PCN#:21030401

Product Change Notice

0.85inch Tab-down Combo type

Part Numbers Affected: 0.85inch Tab-down COMBO

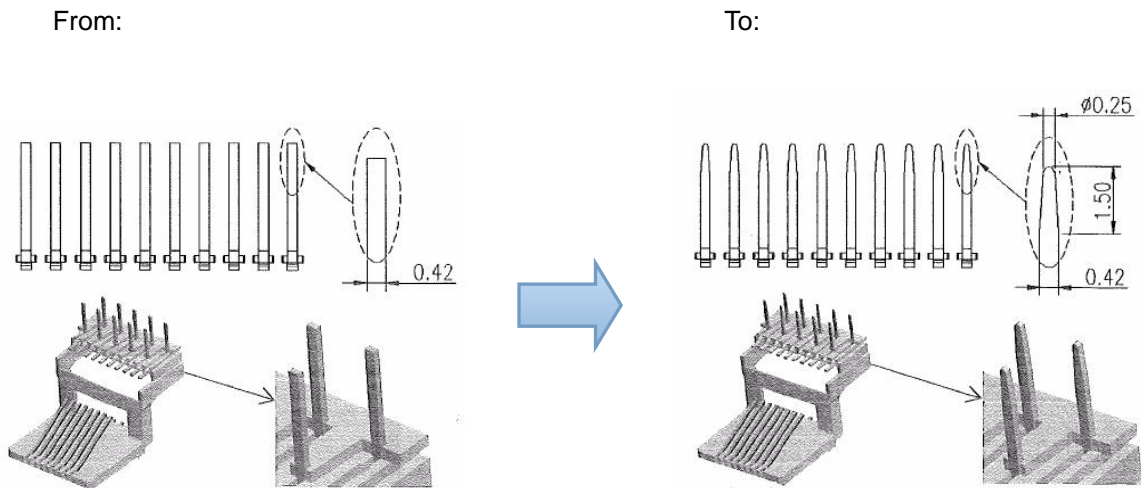
Description of change: square head data pin tip, replaced by deep-chamfer data pin tip.

Reason of change, Blanket change made at data-pin tooling manufacturer, for insertion improvement on system board.

- Note. 1. Function: No change,
2. Physical dimension: No change,
3. Electrical spec (performance): No change.
